NL-07-120

SUBJECT: **Response to Request for Additional Information Regarding
Relief Request 3-43 for Temporary Repair to Service Water Pipe**

REPLY TO REQUEST FOR ADDITIONAL INFORMATION REGARDING
INDIAN POINT 3 RELIEF REQUEST 3-43 FOR
TEMPORARY NON-CODE REPAIR TO SERVICE WATER PIPING

INDIAN POINT 3 RELIEF REQUEST 3-43, REVISION 1 REGARDING
TEMPORARY NON-CODE REPAIR TO SERVICE WATER PIPING

INDIAN POINT UNIT 3
RELIEF REQUEST 3-43, REVISION 1
PAGE 6 OF 6
FIGURE A

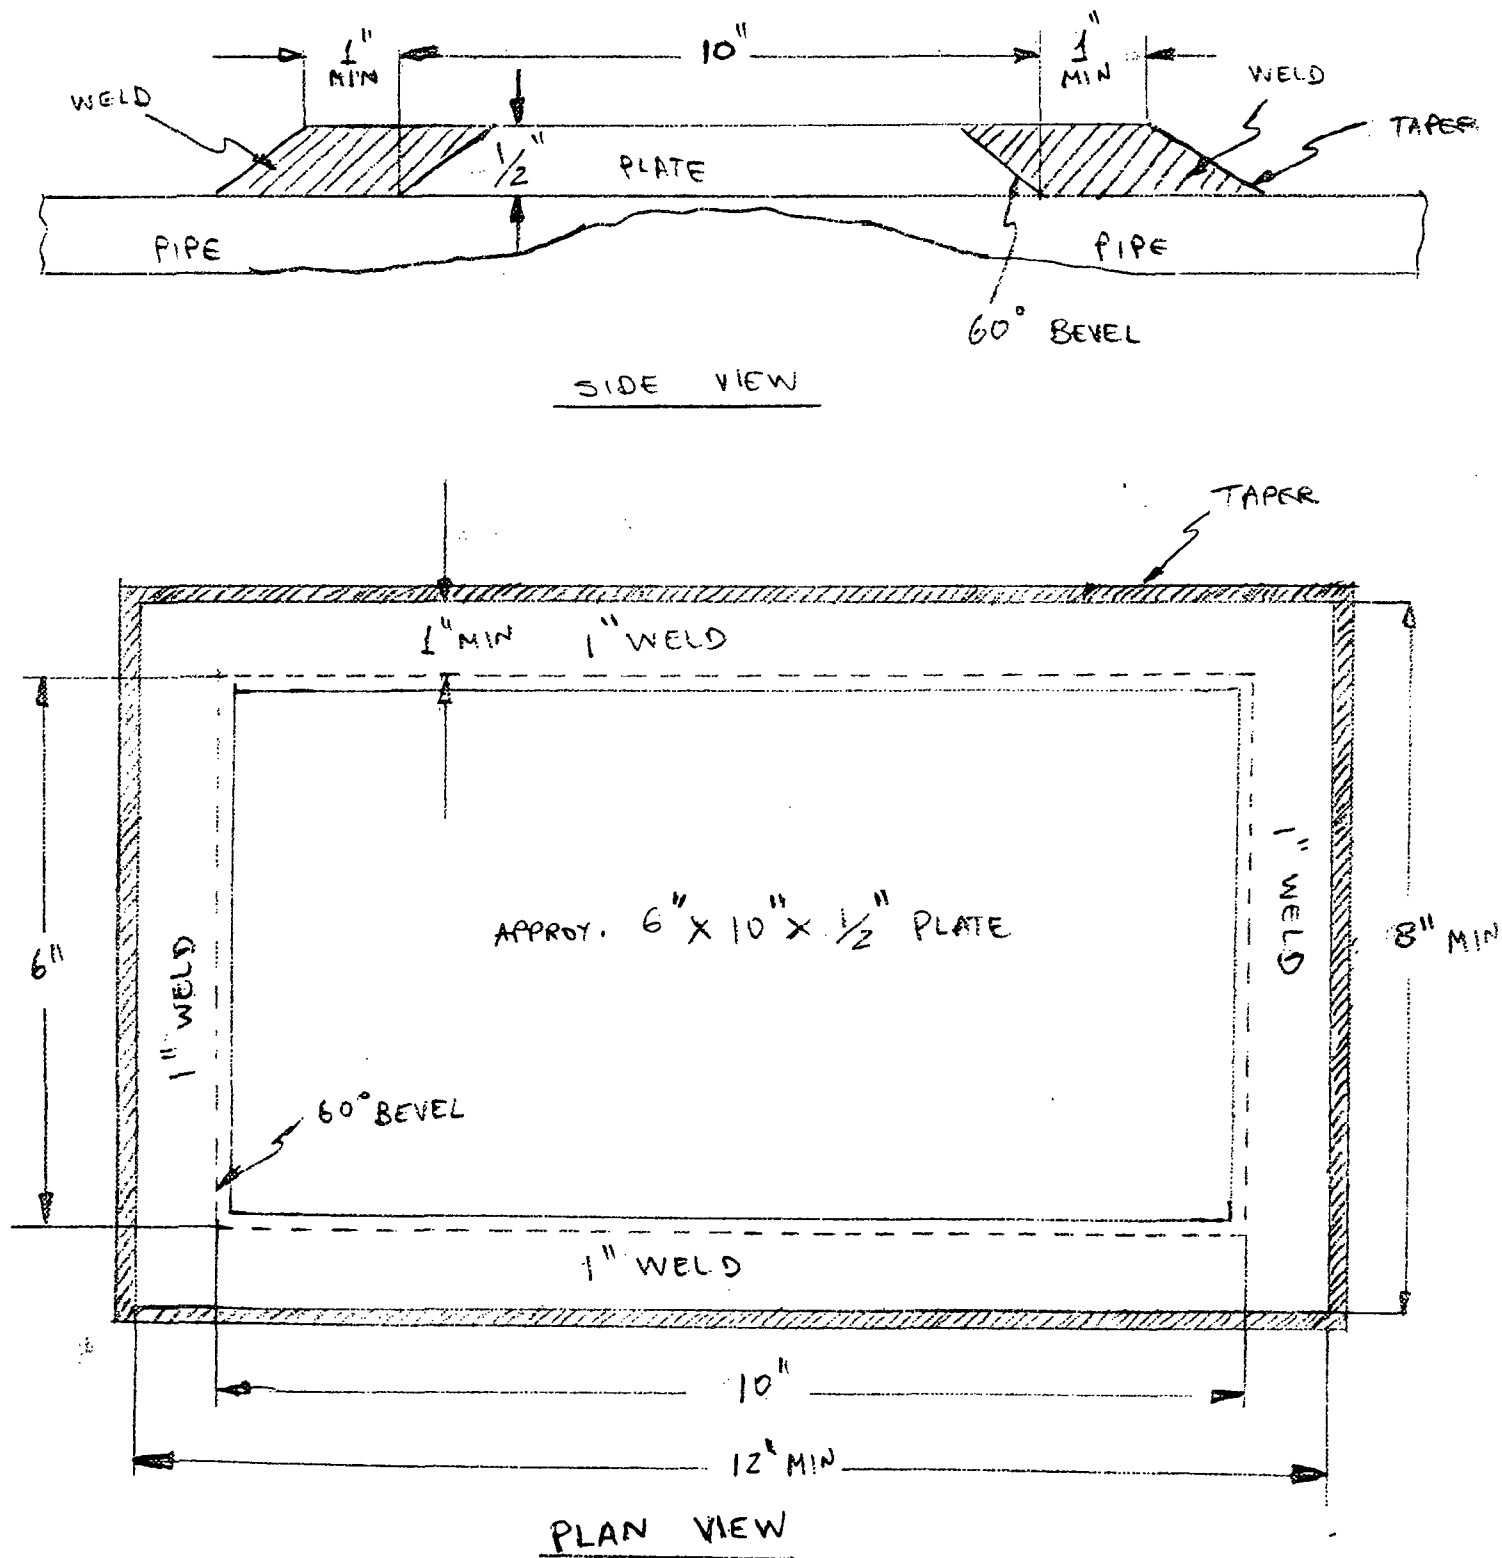
- Additional description of the proposed repair has been added to the revised Relief Request, including dimensions and weld detail provided in Figure A. The reinforcing plate will be fabricated to match the contour of the repair area to the extent practical and the perimeter gap will be maintained within the limits of the procedure for this type of weld.
- The design calculation, including the applied stress allowables and safety factors, is provided in Attachment 5.
- The welding of the reinforcing plate will be in accordance with applicable requirements of ASME Section XI, with qualified welders using a welding procedure qualified per ASME Section IX.

Inservice monitoring of the repair will be accomplished by applying a 1-inch by 1-inch grid over the area which will cover the reinforcing plate and the flat portion of the attaching weld (refer to Figure A). The intersection points in the grid will be inspected using straight beam UT. An initial baseline UT will be performed after installing the repair. Subsequent UTs will then be performed to verify that the structural requirements of the original construction code are maintained through the remainder of the current operating cycle. The UTs will be performed monthly for the first quarter and if no unexpected degradation is identified, UTs will then be performed quarterly for the balance of the duration of this relief request.

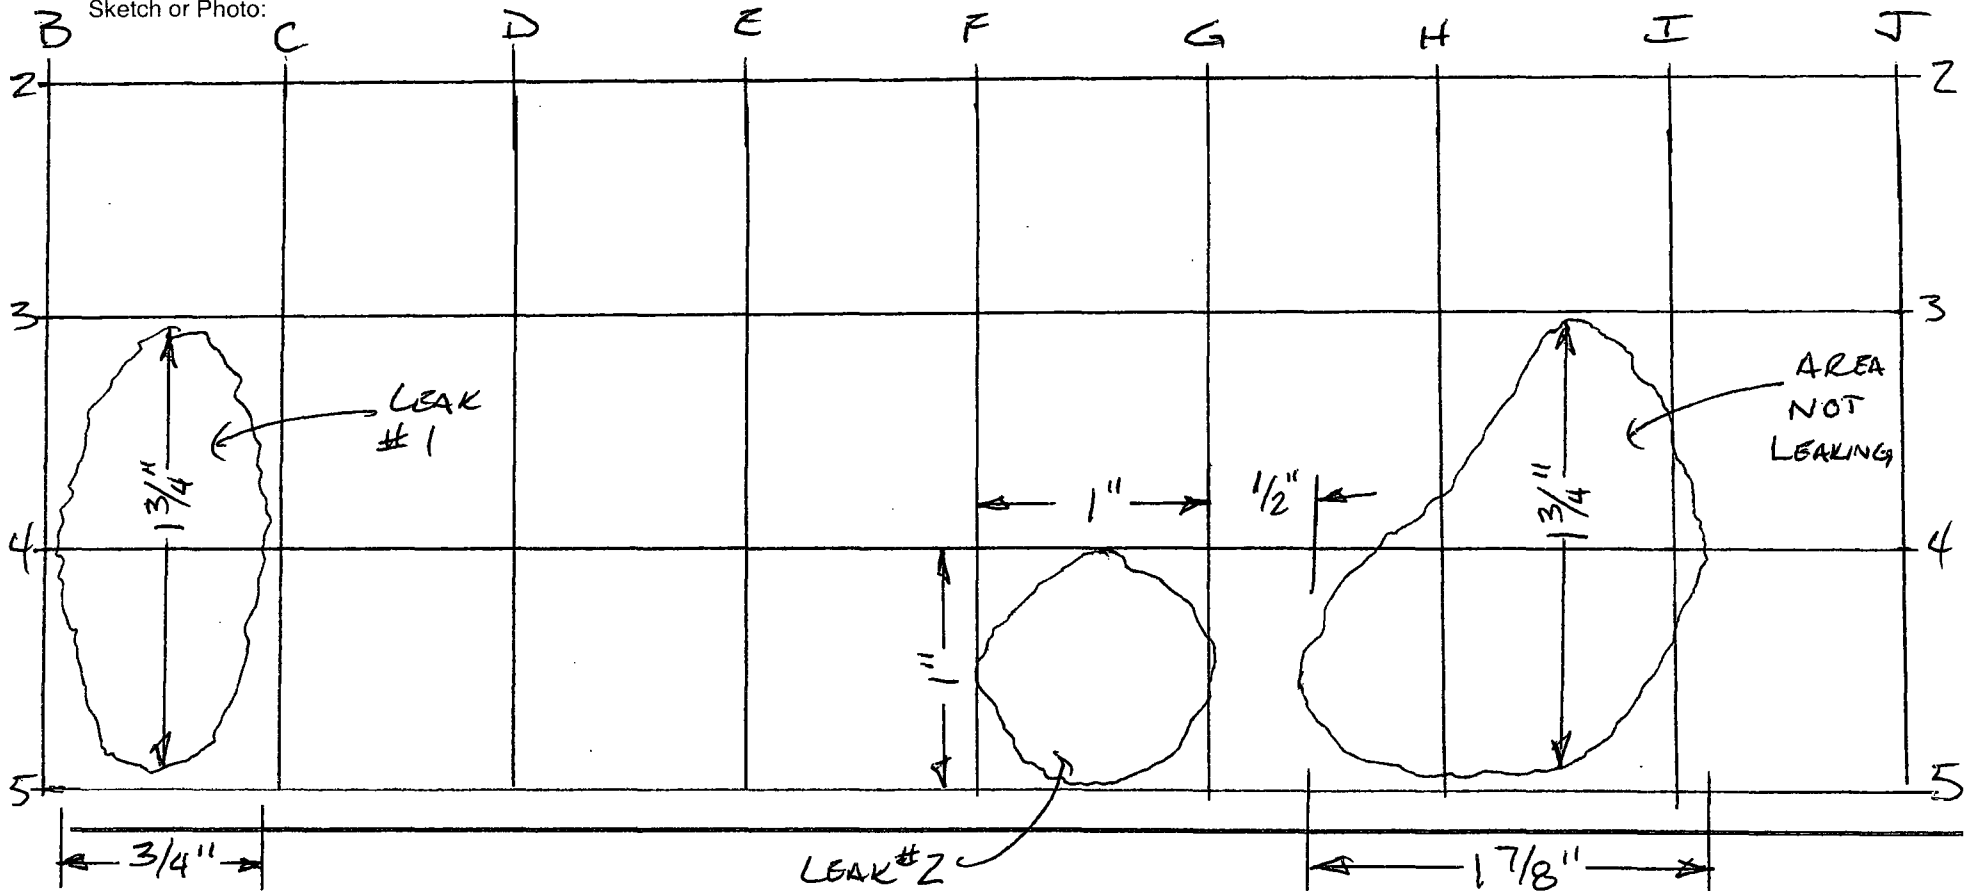
Comments: Scan of the elbow micro grid showing the areas that are less than .109" thick. These areas are around both through wall leaks and the grid locations H4 and I4. Leak #1 is contained in grid B3-B4-C3-C4, and leak #2 is contained in grid F4-F5-G4-G5.

REPORT NO.
1P3-UT-07-049

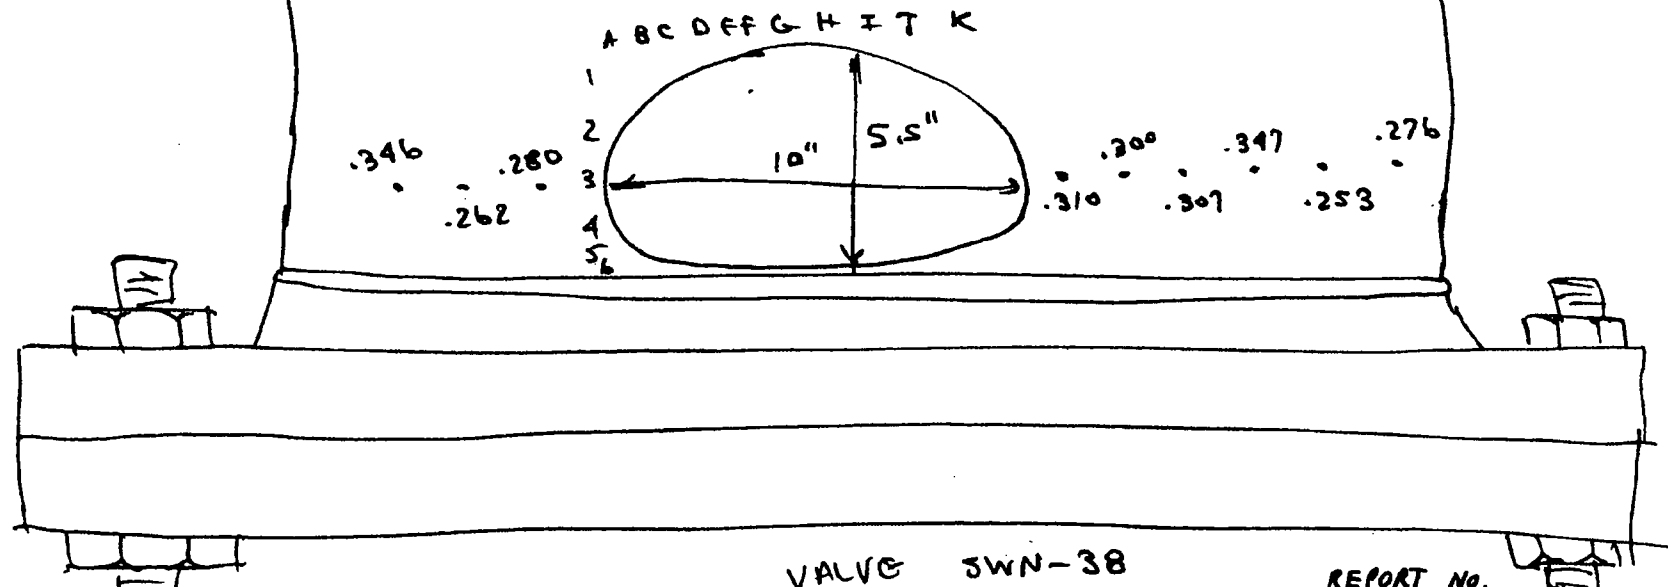
The location of the March 2007 repair with respect to the current area of interest is adjacent to grid location H6 as shown on the UT map in IP3-UT-07-110. A final assessment of why a new through-wall leak developed near the area of the prior repair has not been completed at this time. Further characterization of the degradation in this elbow will be accomplished when the component is replaced.

ALL THICKNESSES OUTSIDE OF
THE LINE ARE > 0.210.
AREA OF INTEREST IS
10" X 5.5"
